# CITY OF ALBUQUERQUE

RE: **Cliffs Unit 18 SAD 228**  
**6600 Kimmick Rd. NW**  
**Grading and Drainage Plan**  
**Engineers Stamp Date 5/12/2020 (D10D003M8)**  
**Pad Certification Date: 6/30/2020**

PROJECT NAME: VOLCANO CLIFFS 6600 KIMMICK DR NW PULTE ID 12

SHEET TITLE: GRADING AND DRAINAGE PLAN

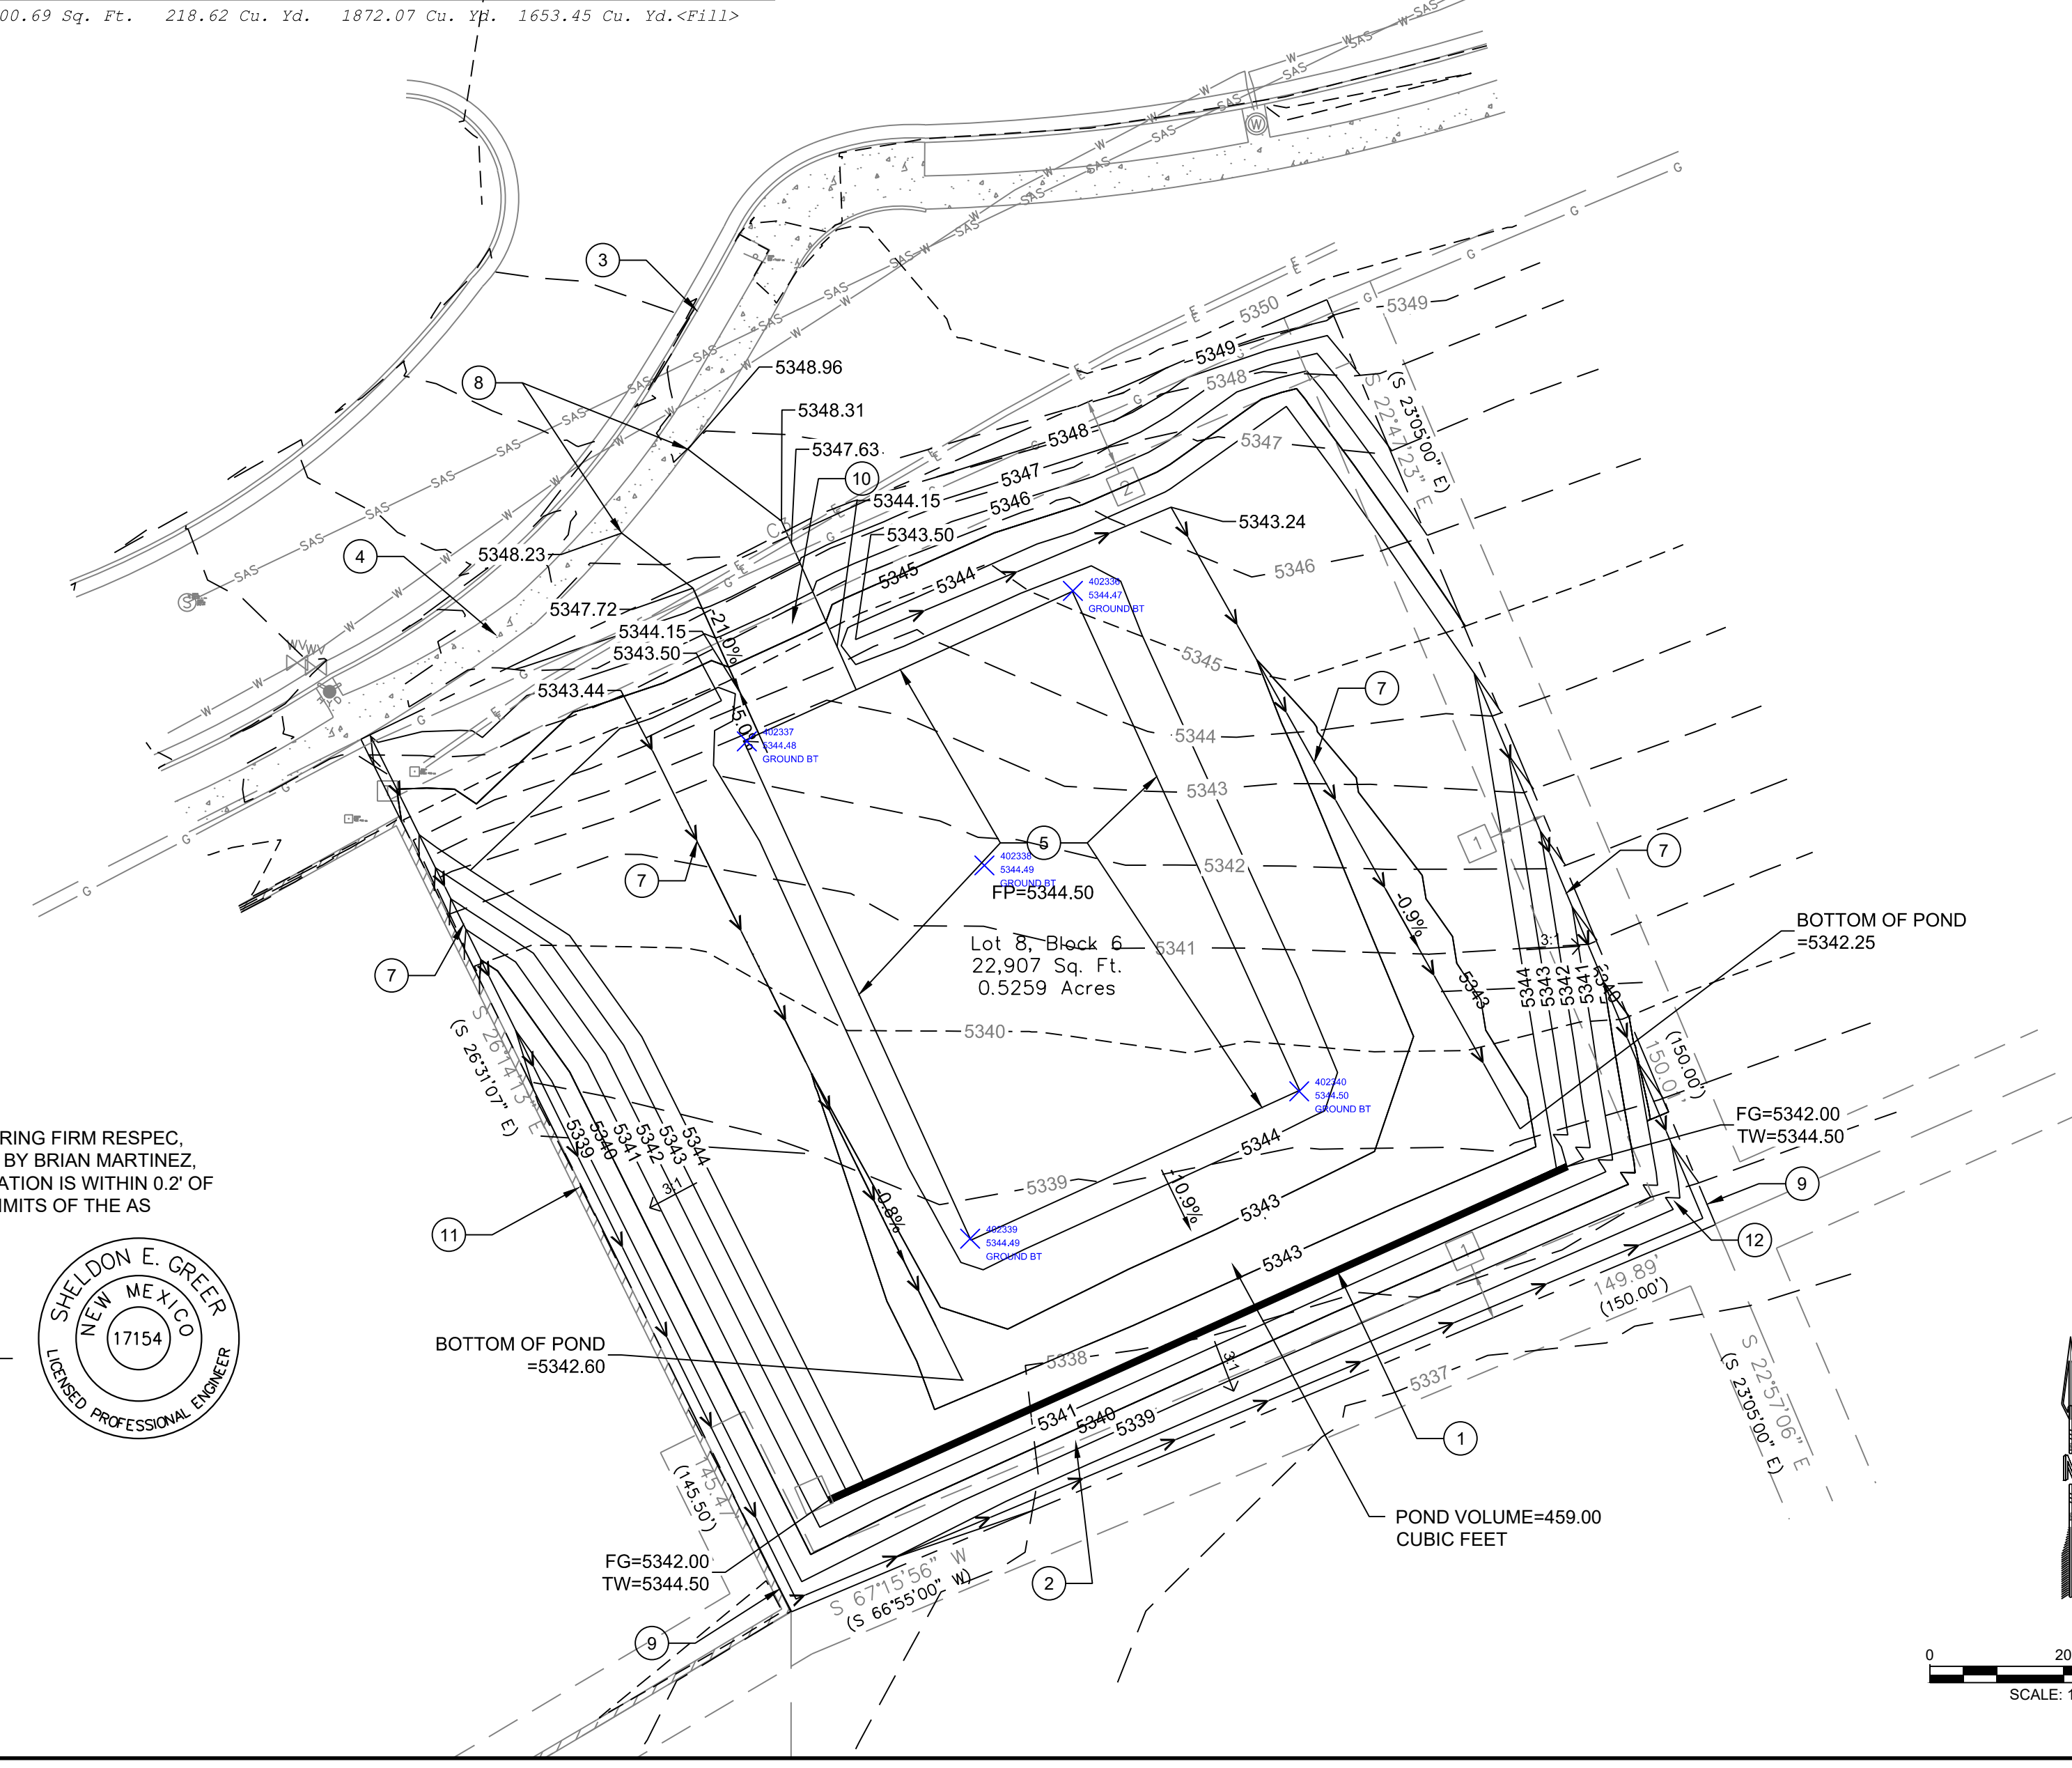
Based upon the information provided in your submittal received 7/6/2020, this plan is approved for Building Permit.

Please attach a copy of this approved plan to the construction sets in the permitting process prior to sign-off by Hydrology.

**Prior to Building permit approval a Pad Certification will be required, provided by the Engineer or a registered Land Surveyor.**

Reiterate to the Owner/Contractor that a separate permit for a garden/retaining wall must be obtained with the approved G&D plan and Pad Certification. **Also, if a swimming pool is to be placed the grading and drainage plan will change and will need to be resubmitted.**

**Prior to Certificate of Occupancy release, Engineer Certification per the DPM checklist will be required.**
